ISSUE: Permit to Demolish/Capsulate (partial) and Certificate of Appropriateness

APPLICANT: Clare and Jen Little

709 South Lee Street

Docket #6 & #7 BAR #2022-00007 & 2022-00008 Old and Historic Alexandria District July 20, 2022

Figure 1 - view from South Lee Street sidewalk

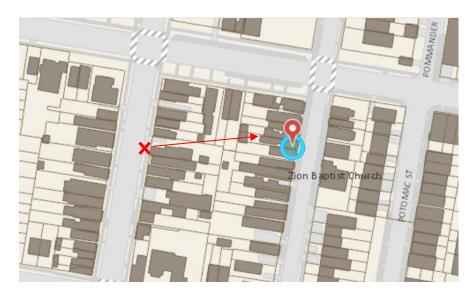
The property sits on the west side of the 700 block of South Lee Street. There is no alley or vacant lot adjacent to the property. However, the rear of the house is minimally visible from South Fairfax Street, from a certain angle, see map below and Figure 2.

2 | WEST ELEVATION - PROPOSED

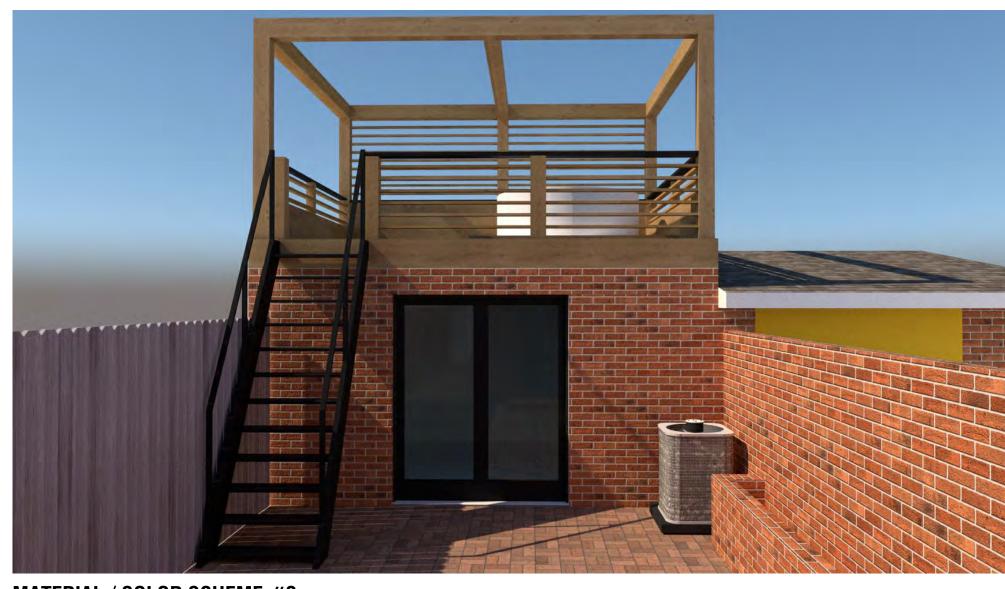
The project calls to extend the existing rear masonry chimney and install a new six-over-six, double-hung window on the second story of the main block, west side.

accommodate a more modern and functional interior layout as tastes and technology evolve. The existing rear elevations do not exhibit a high level of design or architectural detail as well. However, the proposed new window on the main historic block will be visible from South Lee Street and must follow the window policy, which requires that new or replacement windows on portions of the building built prior 1934 be made of wood in addition to comply with the Alexandria New and Replacement Window Performance Specifications in the Historic Districts.

Staff recommends approval of the Permit to Demolish/Capsulate (partial), Certificate of Appropriateness with the condition that the new window on the main block be made of wood and comply with the *Alexandria New and Replacement Window Performance Specifications in the Historic Districts*.
